FIRST AMENDMENT TO THE  
DRAFT  
ENVIRONMENTAL IMPACT REPORT

GOBLE LANE  
MIXED-USE DEVELOPMENT  
FOR PLANNED DEVELOPMENT  
REZONING  
PDC02-066/NR05-001

SCH No. 2005022057

City of San José  
June 2005

# Intersection #42: MONTEREY HIGHWAY & PROJECT SITE ENTRANCE

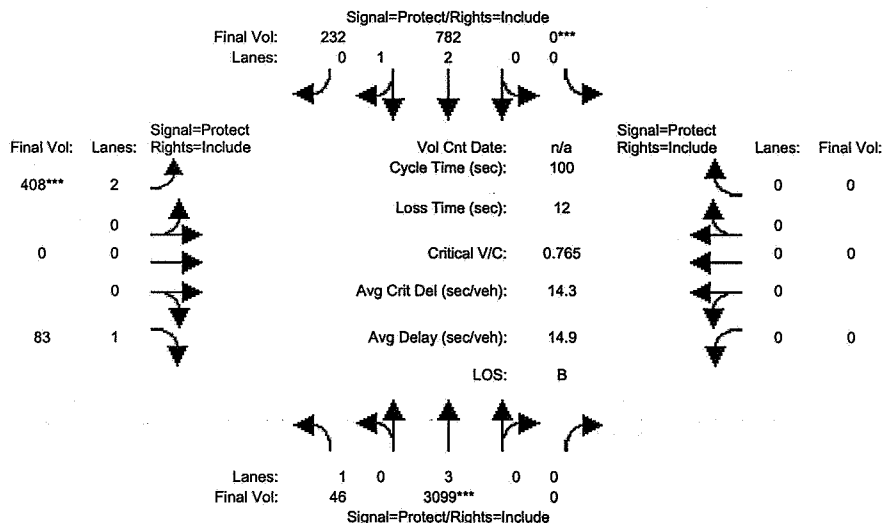
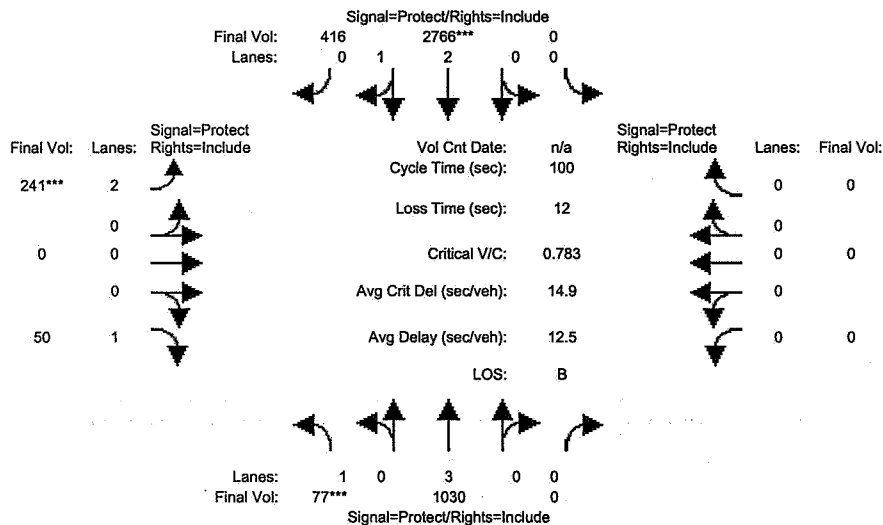
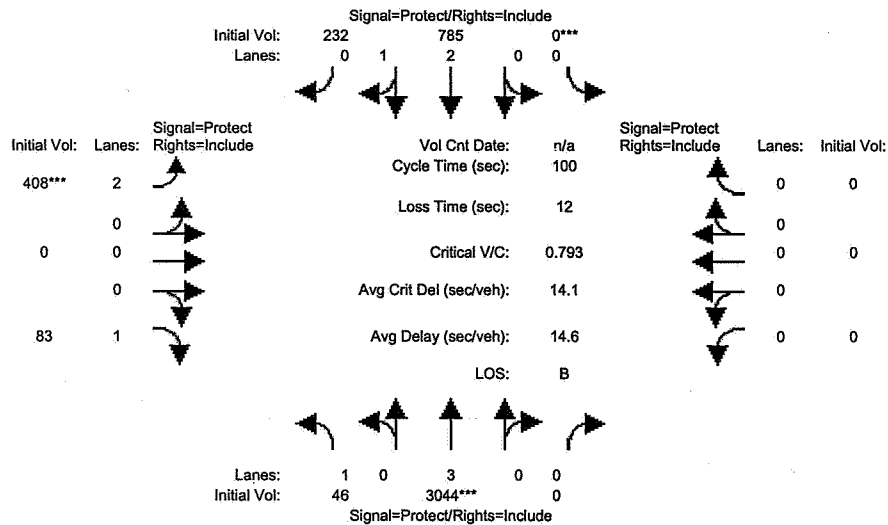
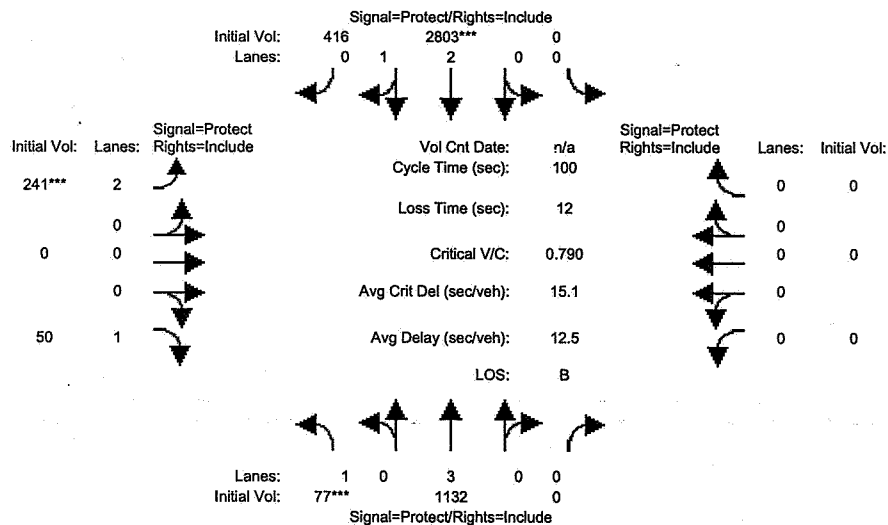
**Comment C27:** Project Conditions: The intersection analysis for intersection #42 is missing. Please submit one for our review.

**Comment C28:** Cumulative Conditions: The intersection analysis for intersection #42 is missing. Please submit for our review.

**Response C27:** The Project and Cumulative Conditions LOS TRAFFIX sheets for Intersection #42 are provided in Section VI of this document. A complete copy of the revised TIA will be provided to Caltrans.
